Rezoning Transportation Analysis

Petition Number: 2023-095

Date	Description
9-28-23	First Review (IW)
11-27-23	Second Review (ME)

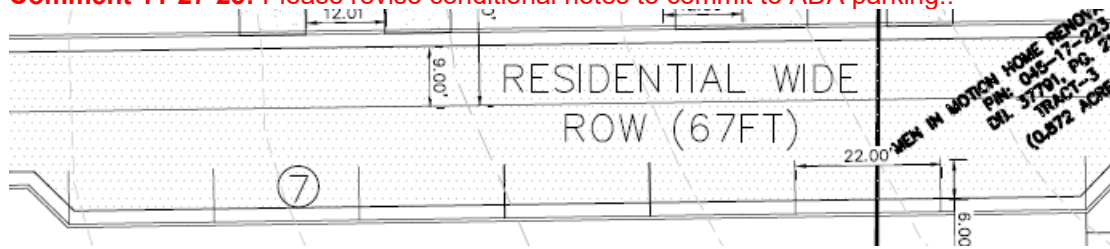
6. Revise site plan and conditional note(s) to commit to providing an ADA on-street parking space to meet Federal ADA guidelines.

Comment 11-27-23: Please revise conditional notes to commit to ADA parking..
